Report on a Publicly Notified Resource Consent Application

Application Reference:	RMA/2020/1877
Applicant:	Wilson's Parking Limited
Site address:	235 Manchester Street, Central Christchurch
Legal Description:	Part Section 688-697 Town of Christchurch
Proposal:	To establish freestanding offsite digital signage
Zoning:	Commercial Central City Business
Overlays and map notations:	Adjoining a Central City Local Distributor; Adjacent to Designation V4 "The Frame – North and East" [Otakaro Limited] Central City Building Height 28m Overlay Category 2: Lower Noise Level Entertainment and Hospitality Precincts Central City Core Overlay; Central City Inner Zone; and Liquefaction Management Area (LMA)
Activity status:	Discretionary
Submissions:	One in support Eight in opposition (Four of these submitters seek to be heard)
Date of Hearing:	1 March 2022
Recommendation:	Decline

Figure 5: Carriageway diagram to show visual overlap

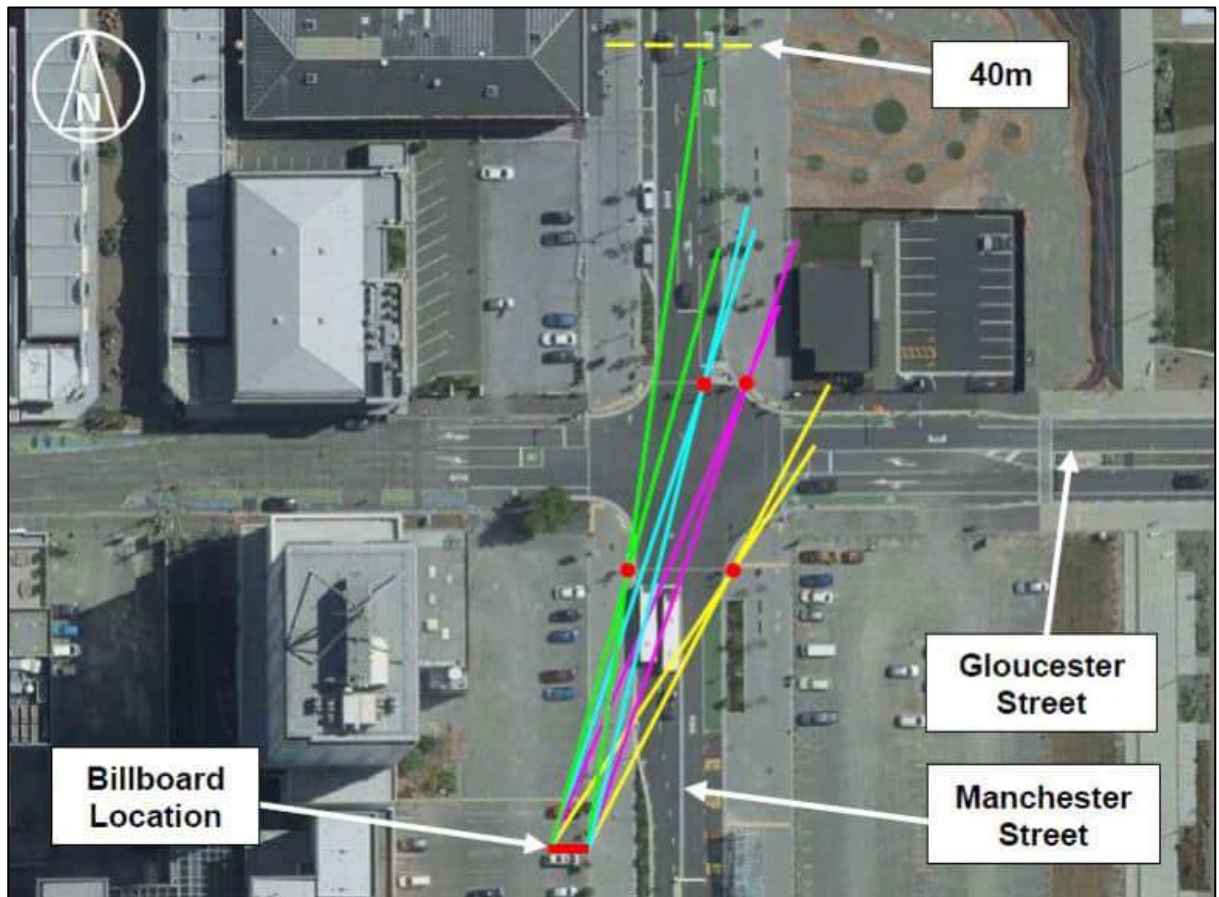
80. Carriageway note that the only overlap that occurs is for the secondary signal head (signal 5 on the SW corner of the intersection) and this arises between the stop line and 35m from the stop line. As the driver approaches the signals, there is no overlap for three of the four signals, and the driver is more likely to be looking ahead to the primary and overhead primary signals. They also note that this occurs in a location where the height difference between the signal and the drivers' eye means that there will be no overlap.

Figure 1: Illustration of proposed 6m x 3m digital billboard and the 9m x 4m x 1m supporting structure

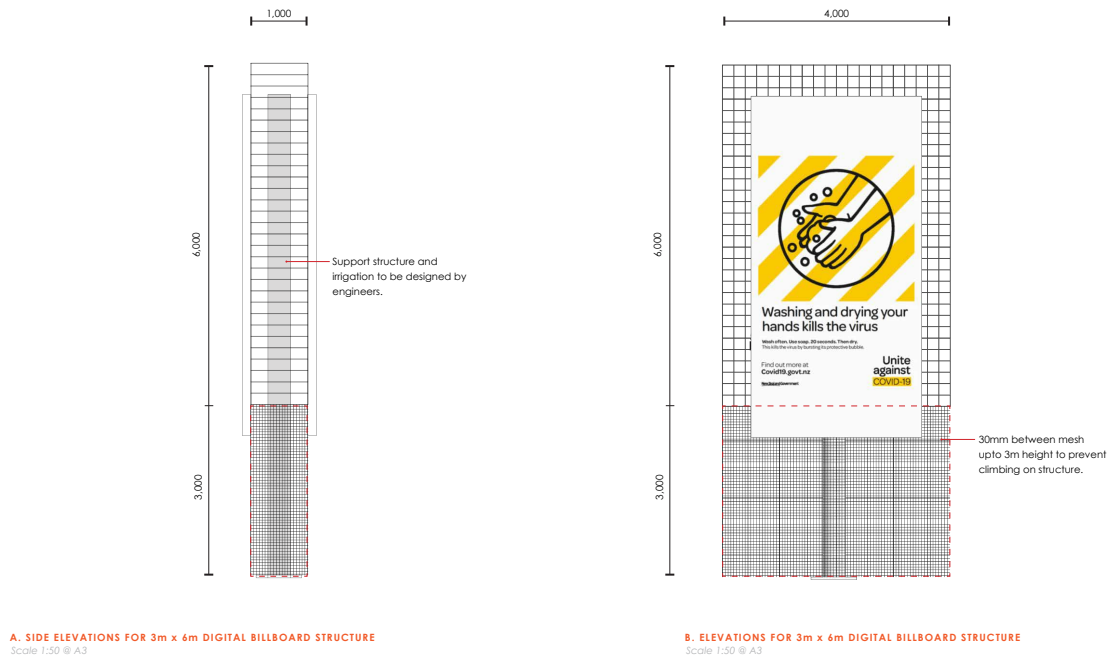
8.1 The application for a digital billboard at 225 Manchester Street proposes a six metre by three metre digital billboard in a portrait orientation. The proposed support structure consists of single circular structural pole with a mesh frame surrounding the sign that is four metres wide and nine metres tall and intended to allow plants to climb around the structure. The lower three metres of the mesh frame has 30mm gaps to make it more difficult to climb.

Figure 1: Reproduction of Figure 9 of the Transport Assessment

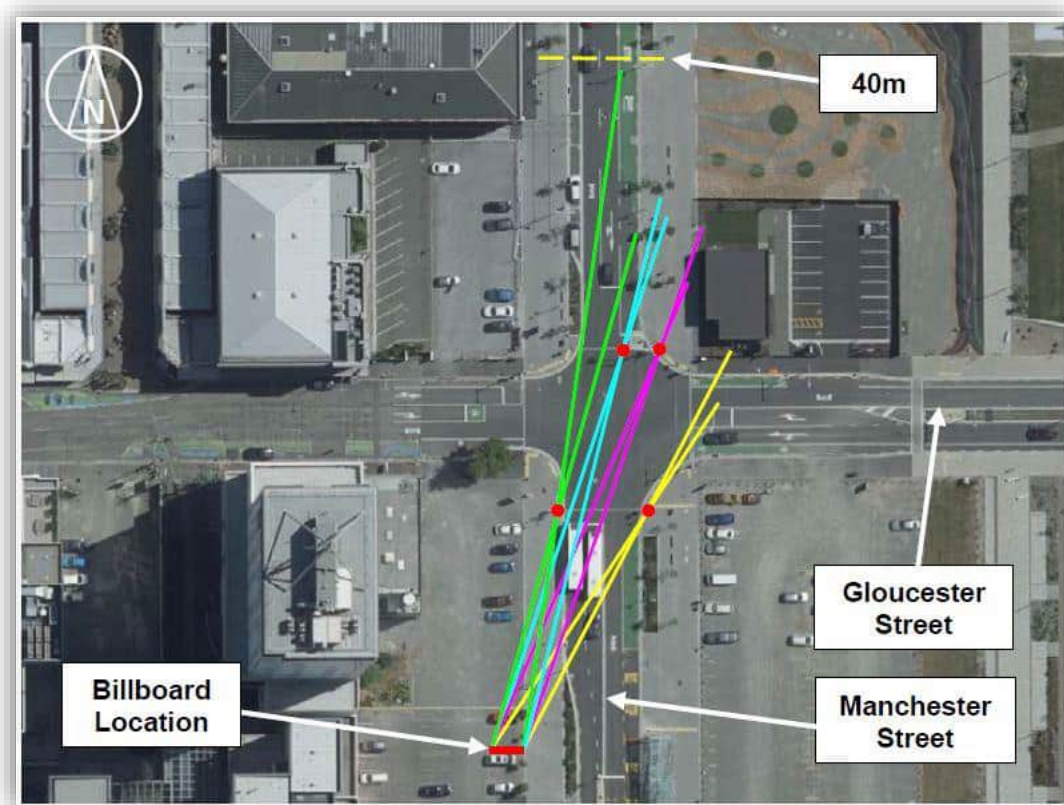
The Transport Assessment does not explain the underlying rationale for considering approach sight distance (ASD) in its section 4.1.2. The area leading up to the ASD lines shown in Figures 9 and 10 could be termed a "critical decision zone". For convenience, Figure 9 is reproduced as Figure 1 below.

Figure 2: traffic signal plan for the Gloucester / Manchester streets intersection

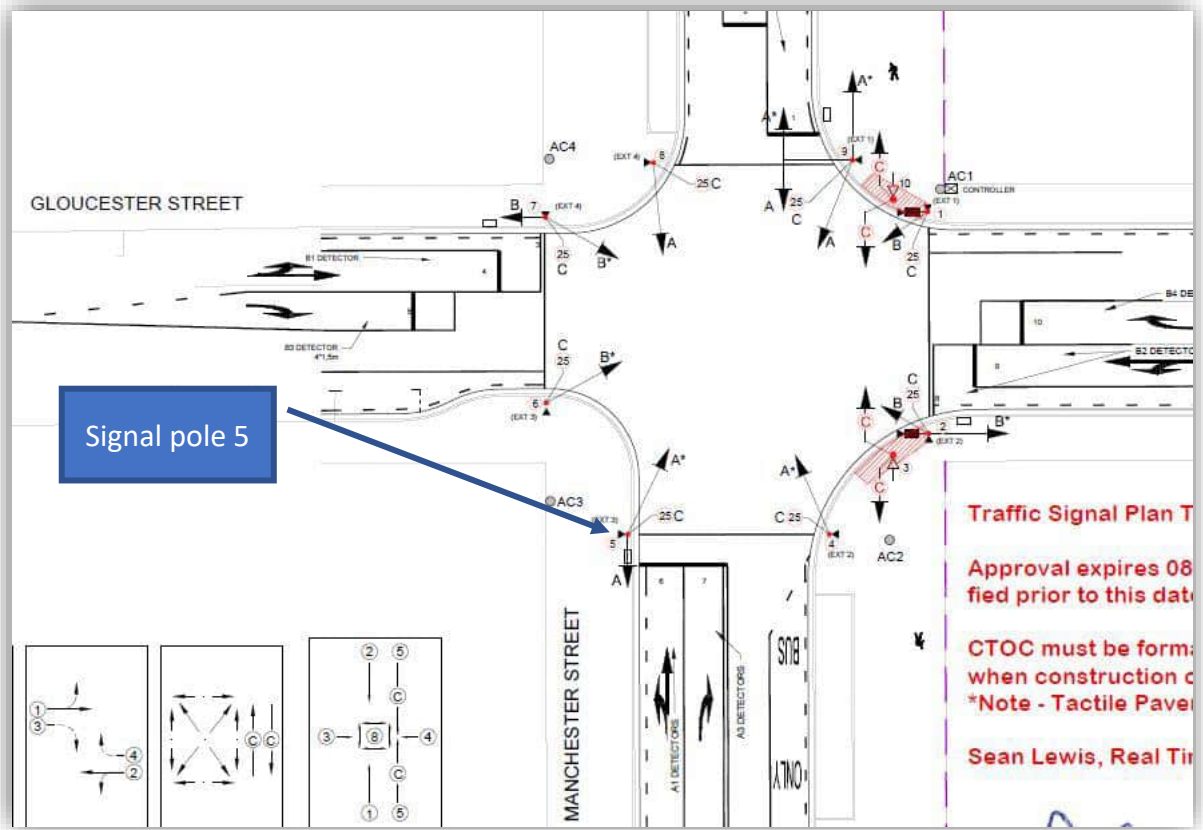
To further discuss these issues, the traffic signal plan for the Gloucester / Manchester streets intersection is reproduced in Figure 2. The green lines in Figure 1 pivot around signal pole 5. ViaStrada’s analysis concentrates on drivers travelling southbound towards Gloucester Street only; the equivalent issues for northbound drivers approaching Worcester Street do not exist. For clarity, our analysis concerns signal pole 5 only; there are no issues with any of the other signal heads.

There are several comments that need to be made to section 4.1 of the Transport Assessment.

Figure 5. Area's of Potential Visual Overlap between traffic signals and billboard at Gloucester Street Intersection.

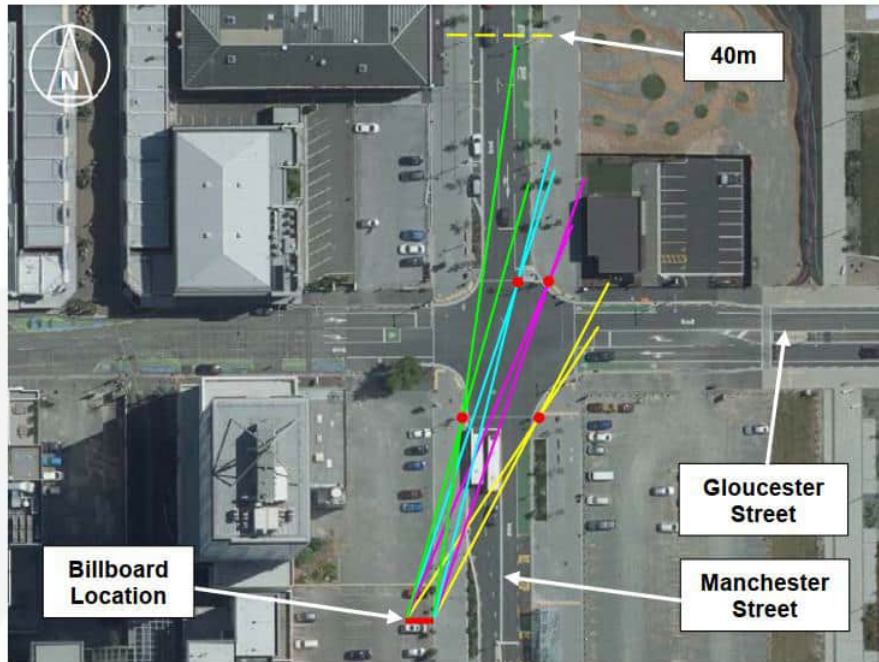
I have accepted and given preference to the advice provided by Mr. Downard-Wilke, for the reasons established below. I acknowledge that I am taking a conservative approach and note that not all information which could and should be provided by the Applicant, has been tabled as outlined in Section 3 of **Appendix 1B**. For this assessment I refer to **Figure 5** which has been reproduced from Mr. Carr's report.
